HISTORIC AND DESIGN REVIEW COMMISSION

May 03, 2017

HDRC CASE NO: 2017-207
ADDRESS: 325 W MISTLETOE
LEGAL DESCRIPTION: NCB 1834 BLK 9 LOT 16
ZONING: R-4 H
CITY COUNCIL DIST.: 1
DISTRICT: Monte Vista Historic District
APPLICANT: Tyler Sibley/Pursuant Ventures
OWNER: Tyler Sibley/Pursuant Ventures
TYPE OF WORK: Fenestration modifications
REQUEST:

1. Remove and replace an original 6 over 1 window on the primary façade with a new 1 over 1 window.

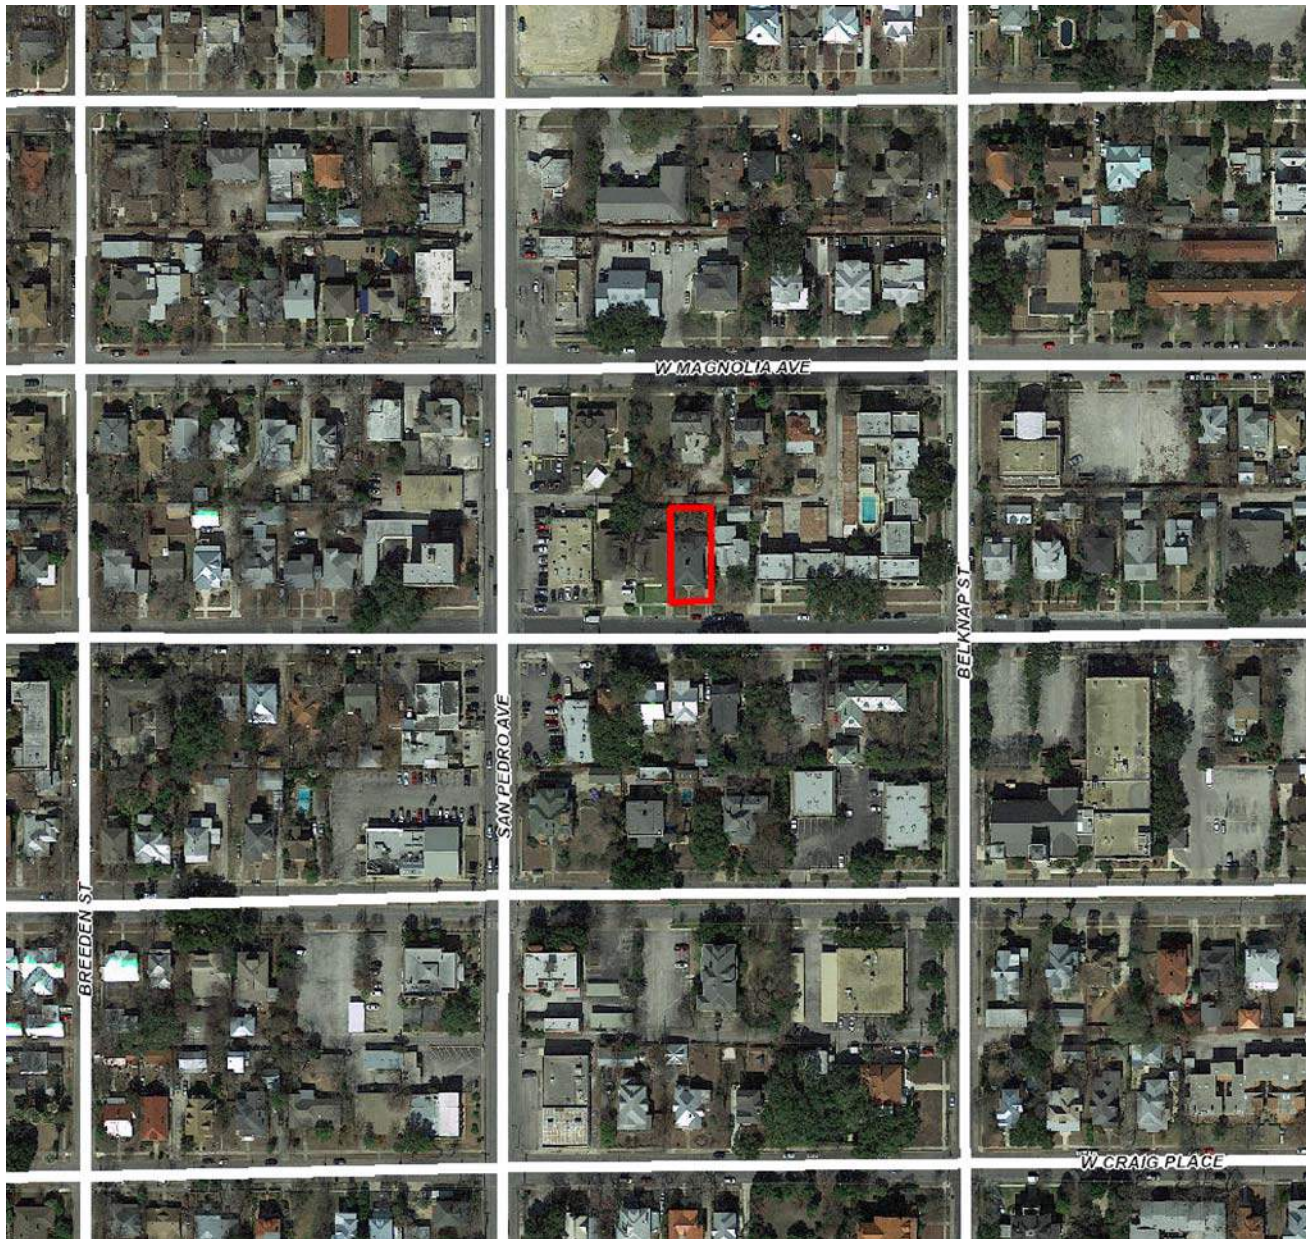
- b. WINDOW REMOVAL – The original 6 over 1 window, located directly to the right of the property’s main entrance, has been removed and replaced without approval. Administrative approval was granted to repair the original window on August 12, 2016. According to the Guidelines for Exterior Maintenance and Alterations, historic windows should be preserved unless deteriorated beyond repair. The proposed removal and reuse of the 6 over 1 window is not appropriate.

- c. HISTORIC TAX CREDIT VERIFICATION – The window was previously deemed repairable when approved for Historic Tax Credit Certification on December 7, 2016. The property is currently in violation for requirements for final Historic Tax Credit Verification and is not eligible for the incentive unless the original window or a salvaged 6 over 1 window is returned in place of the new window.

Staff does not recommend approval of the window removal based on findings a through c.
